# A d d e n d u m

## VWCC Workforce Training Center

**COMM. #:** 21152

### ADDENDUM #: 1

6  
A1.3 3' = 1'-0" NOTE: MATCH EXISTING TPO MEMBRANE

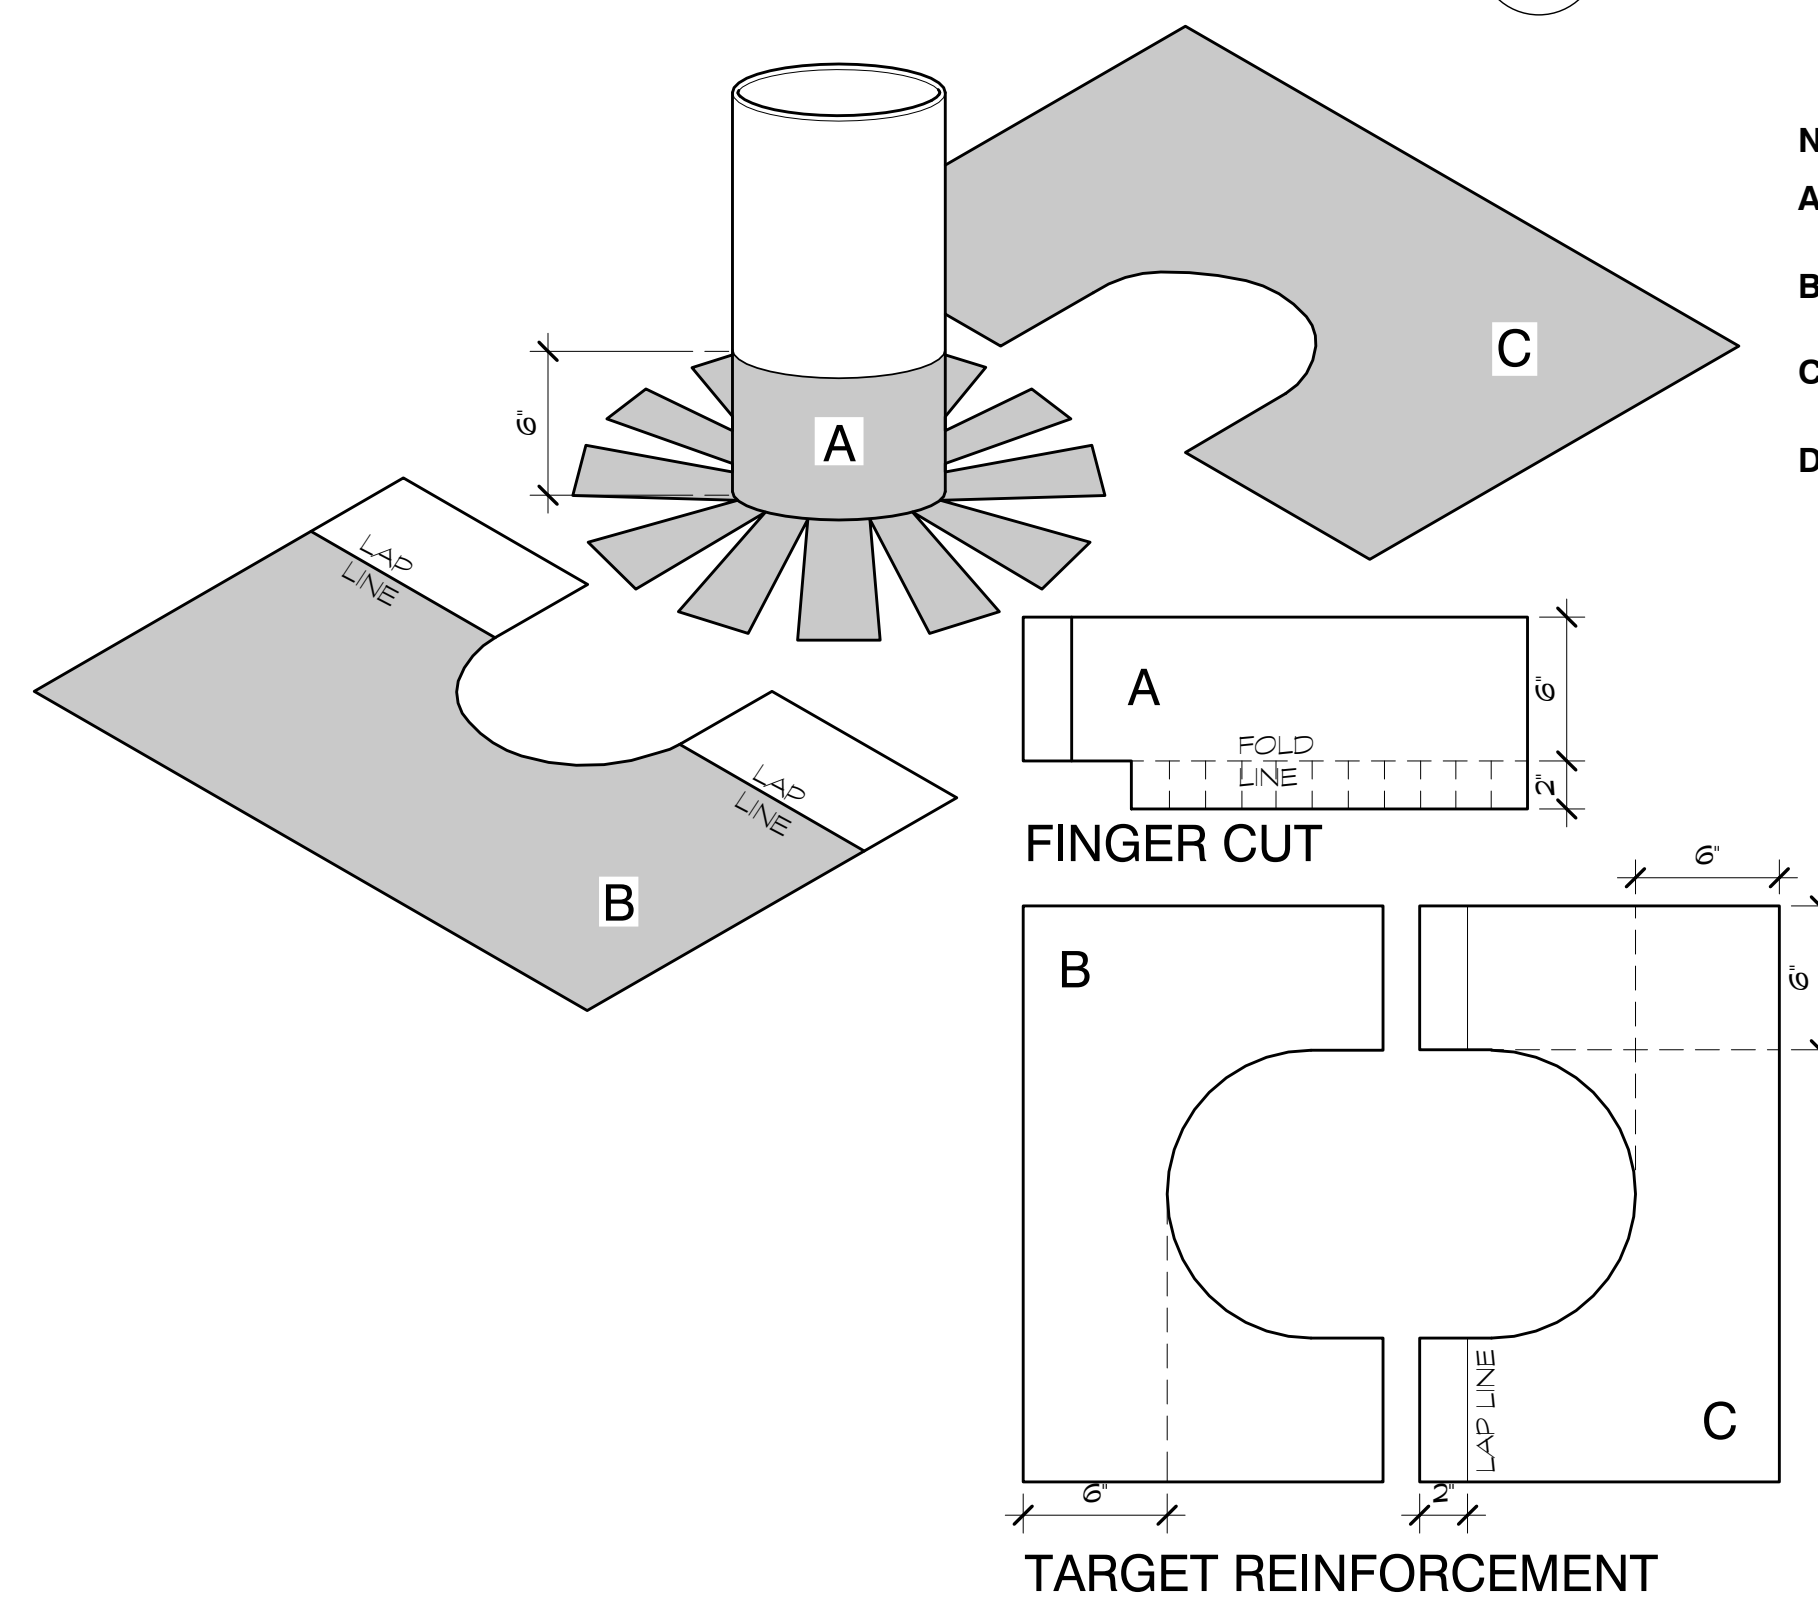
<u>Number</u>	<u>Drawing</u>	<u>Detail No.</u>	
1	2021-11-17_VWCC-GWTC_ADD1_A1.3.pdf	7A1.3	Deleted Detail 6/ A1.3, added Detail 7/ A1.3
2	M4.0	-	Add Sheet M4.0
